# Access Compliance Report

## Public Rights-of-Way

### (Curb Ramps)

Intersection ID: 3145	Main Street: BASKERVILLE_AV	Cross Street: PALLADIUM_PL	Location:	E
ADA ID: EC40460EAC62	Ramp Type: Perp	Initial Pass/Fail: Fail	Overall Compliance: No	Severity Score: 12.5
Codes/Mitigation Info/Possible Solution		Field Measurements/Component Compliance

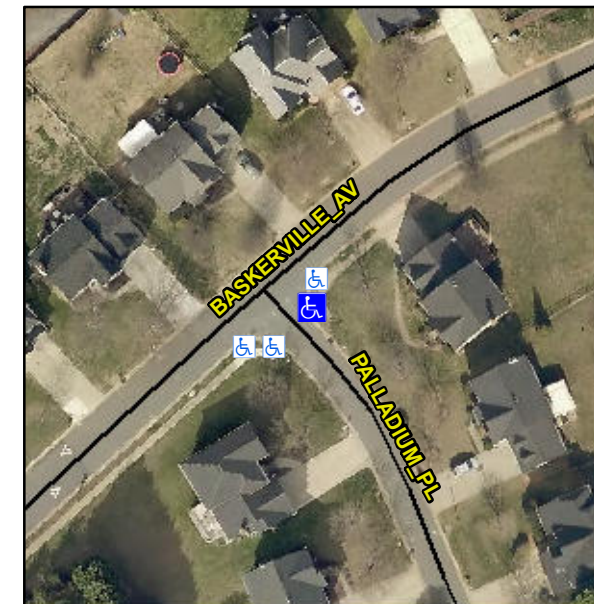
**Not Found, R304.2.2**

Compliance	Description	Data	Compliance	Description	Data
N/A	Ramp Length (in)	46.0	No	Ramp Slope (%)	9.2
Yes	Ramp Width (in)	63.0	Yes	Ramp XSlope (%)	1.8
N/A	Flare Type LT	N/A	N/A	Flare Type RT	N/A
N/A	Flare Slope LT (%)	N/A	N/A	Flare Slope RT (%)	N/A
N/A	Flare Traversable LT?	N/A	N/A	Flare Traversable RT?	N/A
N/A	Landing Length (in)	N/A	N/A	DWS Provided?	N/A
N/A	Landing Width (in)	N/A	N/A	DWS Contrast?	N/A
N/A	Landing Slope (%)	N/A	N/A	DWS Length (in)	N/A
N/A	Landing X Slope (%)	N/A	N/A	DWS Full Width?	N/A
N/A	Landing Curb? (Y/N)	N/A	N/A	DWS Offset (in)	N/A
N/A	Shared Landing?	N/A			
N/A	Gutter Ponding?	N/A	N/A	Gutter Slope (%)	N/A
N/A	Gutter Lip Ht (in)	N/A	N/A	Gutter X Slope (%)	N/A
N/A	Painted X Walk1?	No	N/A	Painted X Walk2?	N/A
	X Walk 1 Direction	To SW		X Walk 2 Direction	N/A
N/A	X Walk 1 Width (in)	N/A	N/A	X Walk 2 Width (in)	N/A
	X Walk 1 Slope (%)	1.1		X Walk 2 Slope (%)	N/A
	X Walk 1 X Slope (%)	1.3		X Walk 2 X Slope (%)	N/A

**Remove & Replace Entire Ramp.**
